**SERVICE BULLETIN**

**APPLICABILITY:** 2013-14MY BRZ

**NUMBER:** 12-200-16R

**SUBJECT:** Rear Combination Lamp and Related Enhancements

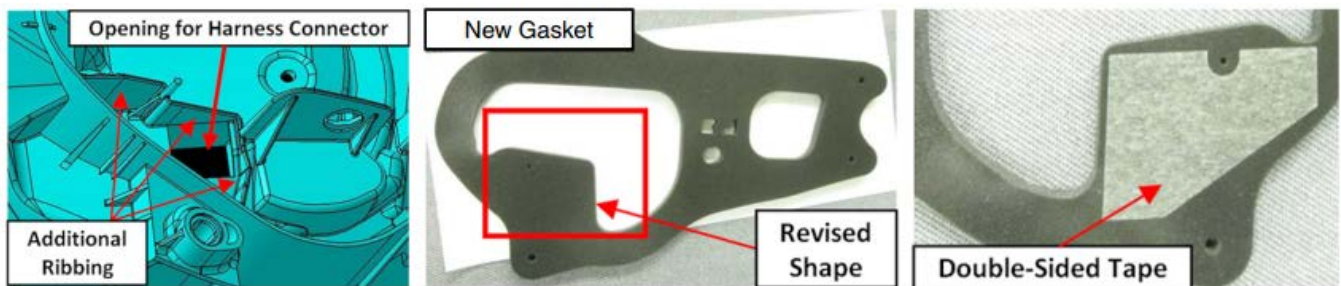
- Flange surface dimension of retaining nuts increased from 12mm to 15mm.
- Thickness of the combination lamp gaskets increased for improved sealing.
- The “height” of the trunk stoppers has been increased by 2.7mm and a liner added to the trunk weatherstrip intended to improve crush resistance and keep the trunk lid from contacting (and in a small number of cases, cracking) the tops of the combination lamps when closing.

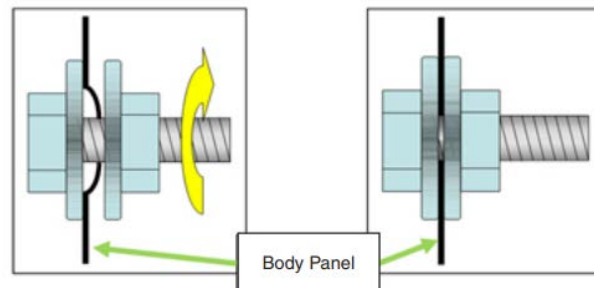
- Take out the 6 retaining clips from the trunk side liners then remove them to gain access to the combination lamp mounting nuts.
- After removing the 4 retaining nuts from each combination lamp, unplug and remove the assemblies.
- Before reinstalling any lamp assemblies, always inspect the rear body panel closely in the retaining nut areas for any deformation of the metal as shown in the illustrations below.

- If any deformation is found, **CAREFULLY** straighten the affected mounting area using a small body hammer and dolly.
- Another straightening method is to clamp the body panel using a bolt, flat washers and a nut as shown in the illustration below.

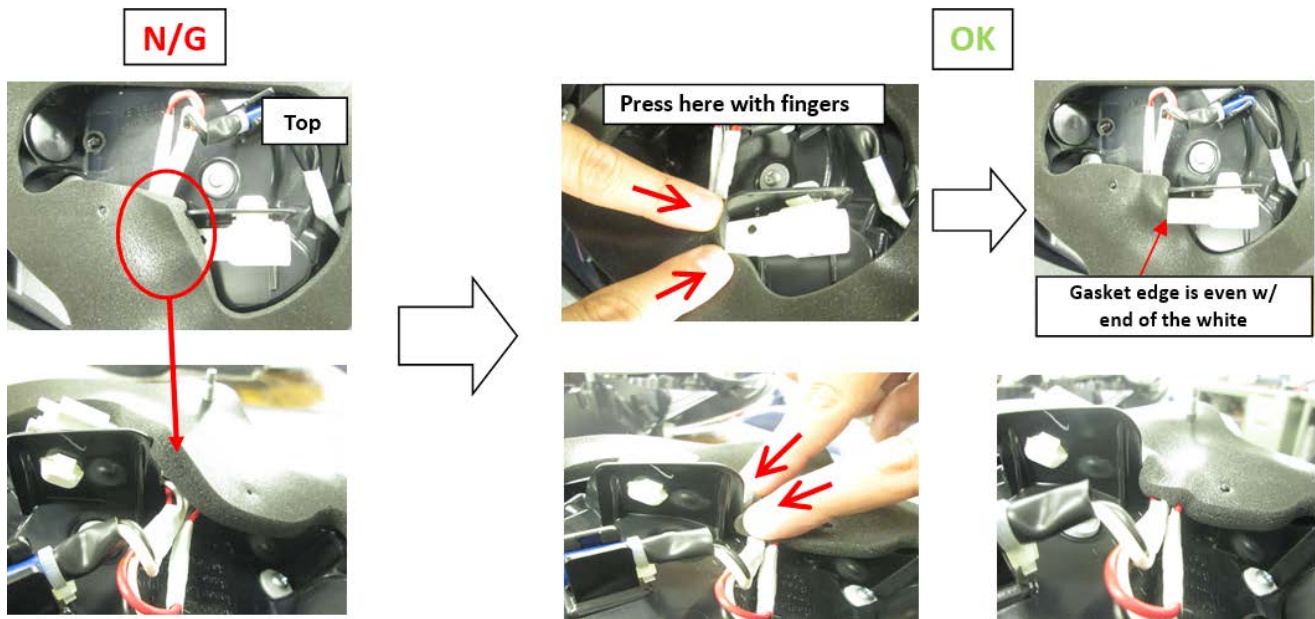
- Inspect the retaining stud boss areas of the housings for any cracking as shown below. If cracking is confirmed, the lamp assy. must be replaced.

**NOTE:** Unless the most recent combination lamp assemblies are already installed, when replacement is required, replace **BOTH** assemblies with the new parts.

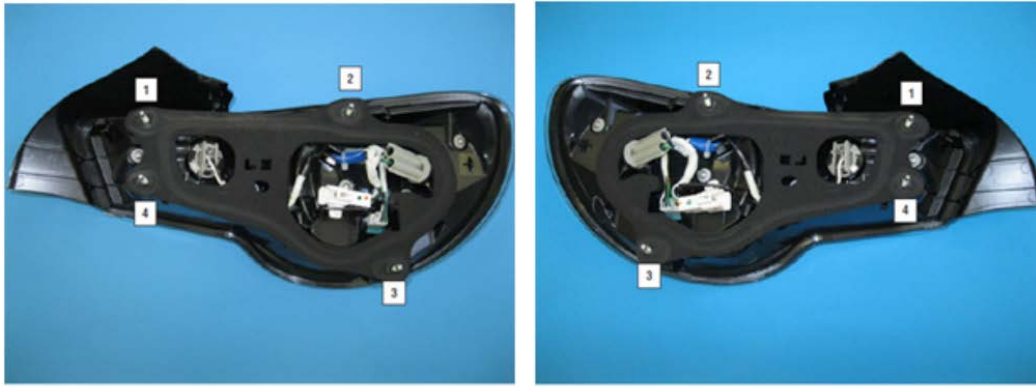
- With the new gaskets in place, refit the combination lamp assemblies to the vehicle but before tightening the retaining nuts, confirm the new gaskets are in the proper position as shown in the photo below (left side shown). **NOTE:** If not already being used, always use the new retaining nuts (p.n. 902370040) which have a 15mm flange / washer portion.

- The proper torque sequence must always be followed as shown in the photos below or damage to the combination lamp assembly may result. The torque specification for the retaining nuts is 4.5 Nm (39 inch-pounds).

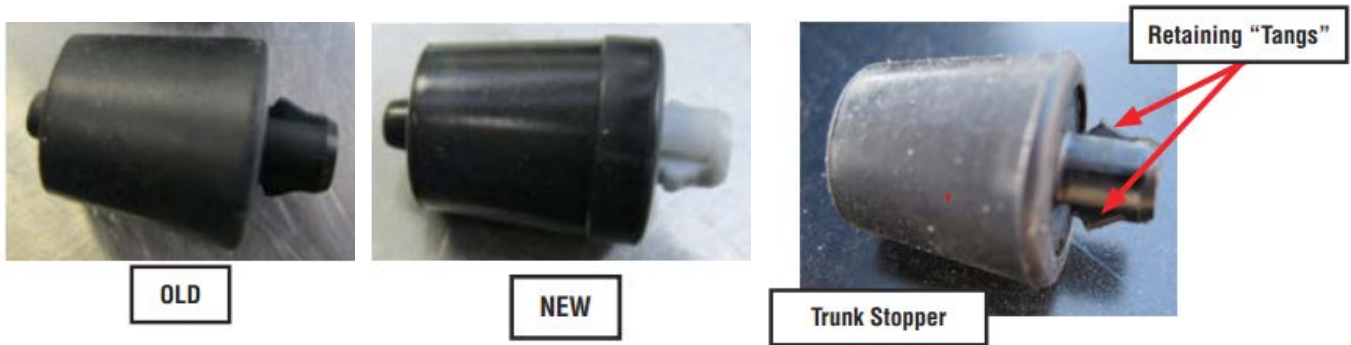
The photos below show the differences between the “OLD” and “NEW” trunk stoppers and the retaining tangs which secure them to the trunk lid.
